Re: ISS Modification
Con Edison White Plains Former MGP Site
Site No. V00438

Re: **White Plains Former MGP Site, OU-2**
Request for ISS Depth Modification
Site No. V00438

Revised In-situ Soil Stabilization Approach due to Changed Subsurface Conditions

DRAWING NO.: C006

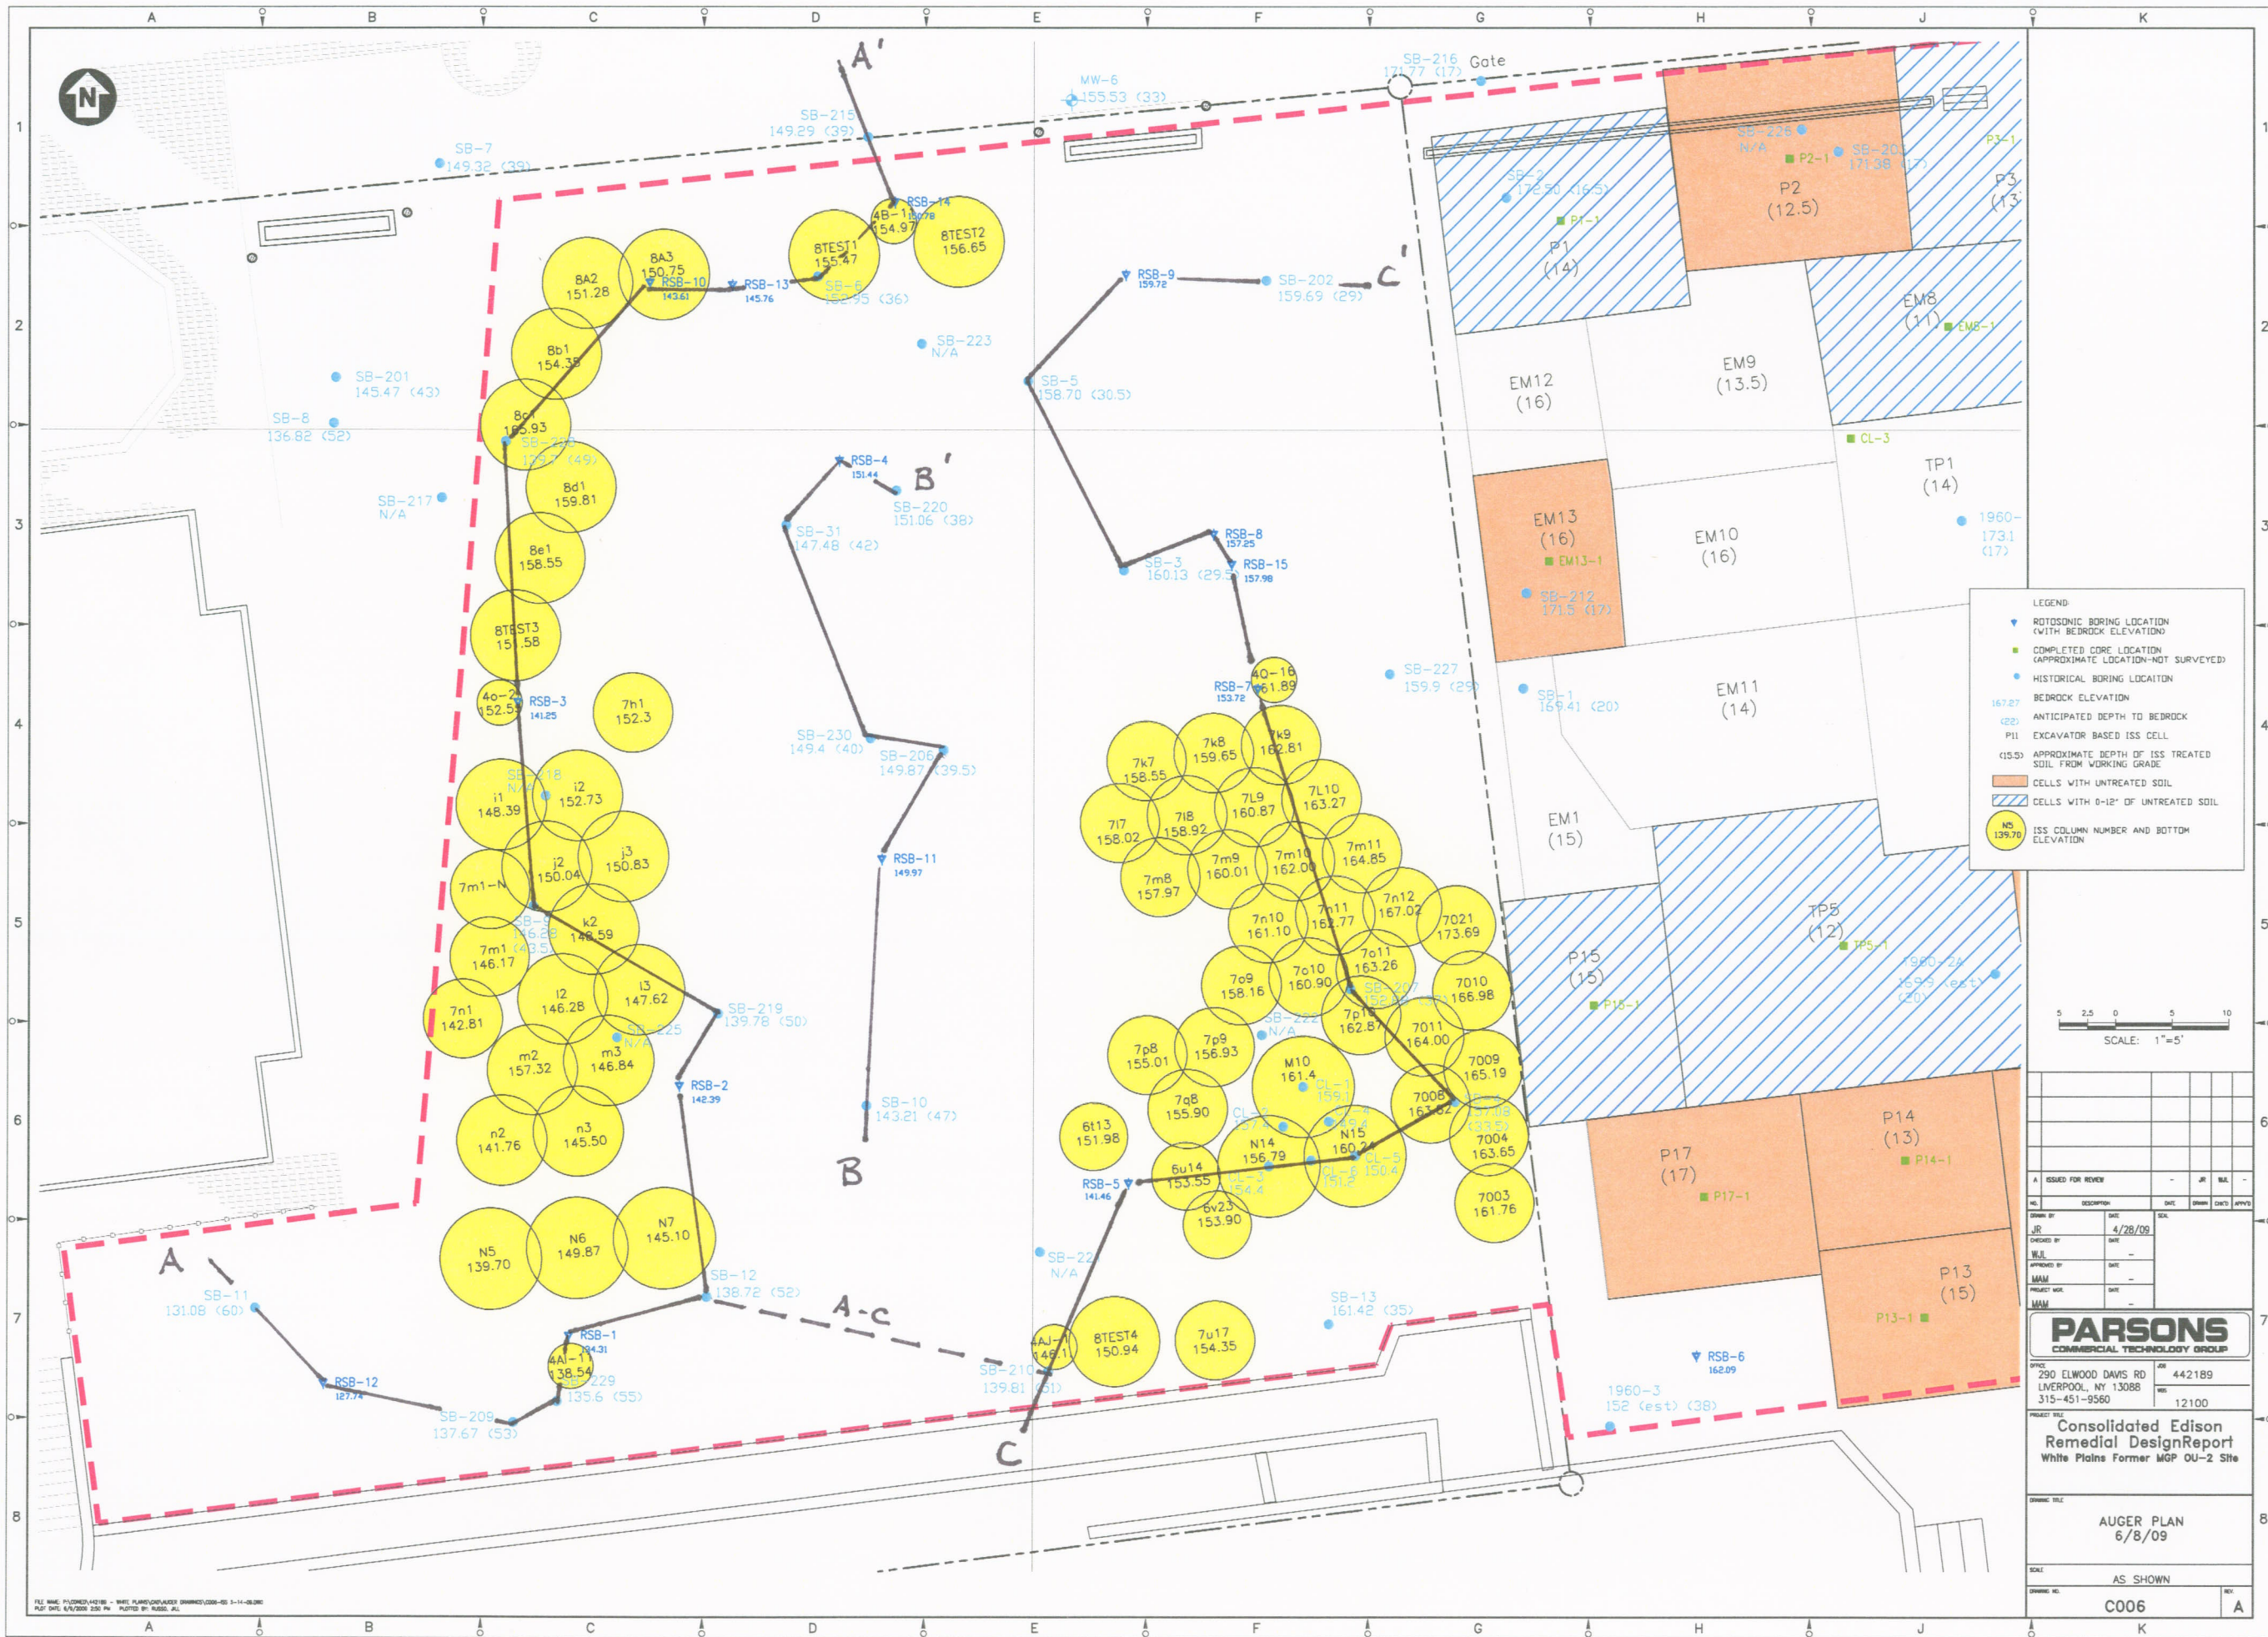
As depicted on Figure C006, various size auger diameters have been utilized by WRSccompass in installing the ISS columns in the auger based ISS area. These auger diameters are listed in Table 1 and all of the augers were mounted on a 4000-series Manitowoc 4000 crane equipped with an attached Hain 450K S-2 drilling platform. The cutting teeth configuration on the various auger sizes were similar with the exception to the 8-foot auger used by WRSccompass on June 1 through 3, 2009 which had a more aggressive cutting teeth design and configuration.

As detailed on Table 1, the 9-foot diameter auger was advanced on average to within 6.4 feet of anticipated bedrock (based on 6 ISS columns), the 8-foot auger advanced on average to within 5.6 feet of anticipated bedrock (based on 11 ISS columns), the 7-foot diameter auger was advanced on average to within 6.3 feet of anticipated bedrock depth (based on 34 ISS columns), the 6-foot diameter auger was advanced on average to within

6.3 feet of anticipated bedrock depths (based on 3 ISS columns), the 4-foot diameter auger was advanced on average to within 6.5 feet of anticipated bedrock depth (based on 5 ISS columns), and the alternate designed 8-foot diameter auger advanced on average to within 11.1 feet of anticipated bedrock depth (based on 10 ISS columns).
